PRODUCT SAFETY

RETROFIT

October 16, 2026

PRODUCTS AFFECTED: EPIQ™ PowerTops™ that have the power strip pictured below:

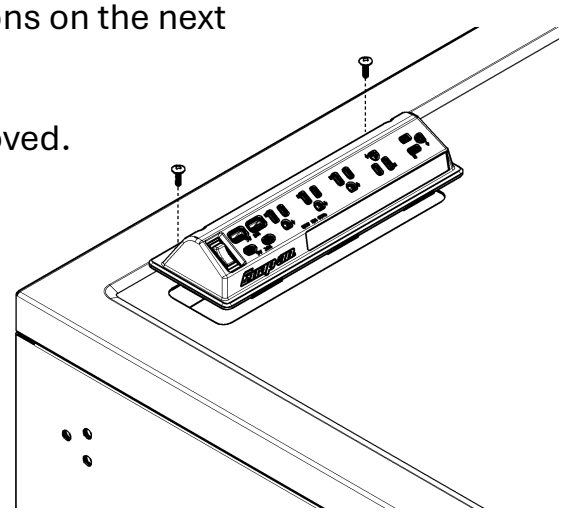
4. Snap-on will send you replacement power strip(s) and a pre-paid return label for your affected power strip(s).

5. Replace the power strip(s) and return the affected power strip(s) using the included pre-paid return label.

NOTE: Replacement is done from the top of the worksurface and takes about 2 minutes. See instructions on the next page and link below.

The PowerTop™ does **not** have to be removed.

Replacement Instructions:

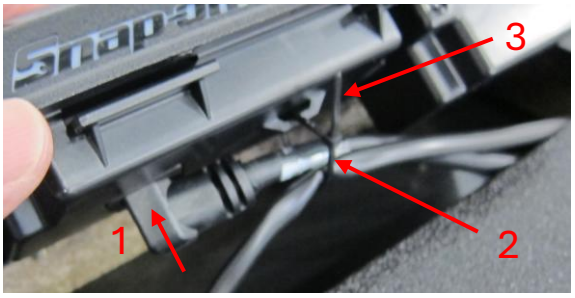
Remove power strip

1. Remove and save two screws
2. Slide power strip rearward

3. Lift up and rotate power strip
4. Clip cable tie

5. Unplug & set power strip aside for return

Install new power strip

1. Plug in power strip
2. Connect cables to power strip using the provided cable tie
3. Tighten cable tie and clip to remove excess

4. Slide power strip forward into opening to align slots with threaded inserts (a)
5. Secure using the (2) saved screws

6. Plug the PowerTop™ in and set the switch to the reset position
